[Docket No. 2000–SW–37–AD; Amendment 39–12449; AD 2001–20–03]

#### **Airworthiness Directives; Bell Helicopter Textron Canada Model 206L–4 Helicopters**

**ACTION:** Final rule.

**Figure 1**

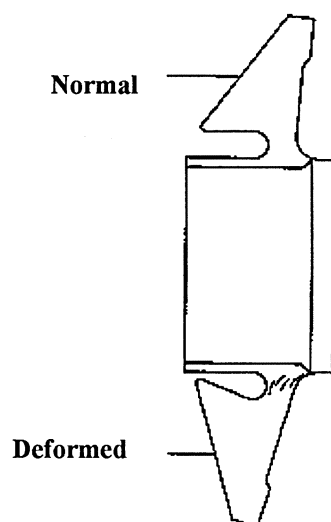
(b) Before each engine start, check the indicator for damage in accordance with Figure 1 of this AD. If damage is found, before further flight, replace the damaged indicator with an airworthy indicator, and replace the tail rotor yoke, P/N 406-012-102-107, with an airworthy tail rotor yoke.
